SOUTHWEST MEDICAL CENTER, INC.

RE: Control # 77312

In response for further information concerning Item #21 of our license renewal application, please find enclosed a revised room diagram and a revised Xenon Radiation Safety program.

ITEM #21  
PROCEDURES AND PRECAUTIONS FOR USE OF RADIOACTIVE GASES

## Diagram

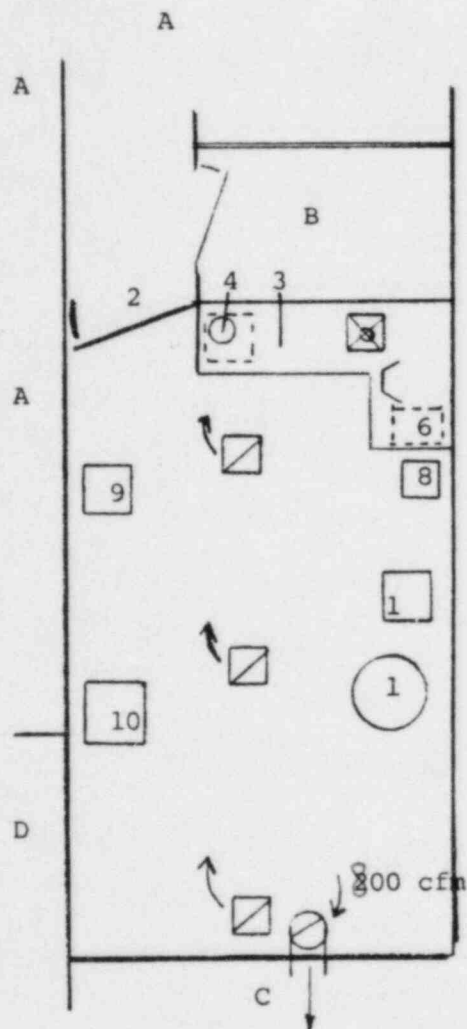
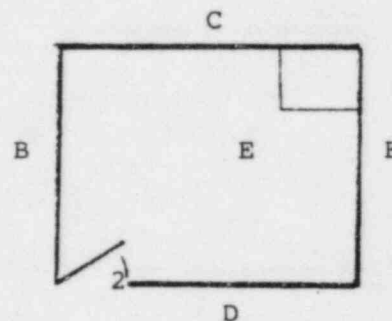
① What Considerations have been made for uniformity of exhaust in each area of the clinic.

a.) How can you be sure Xe-133 will not be exhausted into an area of lower exhaust and be pooled up.

② Submit the imaging area volume and the volume of the entire clinic - with diagrams - showing exhaust in each area

The imaging room is used for the storage and use of xenon.  
(See diagram).
3. Procedures for Routine Use
  - a. The dose will be prepared and assayed in the dose calibrator if possible. Shielding of the dose will be maintained at all times up to patient administration, except during identification and assay. Patients will be instructed as to the procedure and trial runs will be conducted if at all possible. Finger badges and whole body badges will be worn by all personnel handling Xenon. The camera room door will be closed.

4. Concentration in Restricted Areas
  - a. The air handling system of the camera room exhausts at a rate of 800 cfm. No air is recirculated in the building. Supplies to the room will be dampered (if necessary) to achieve negative pressure in the room.
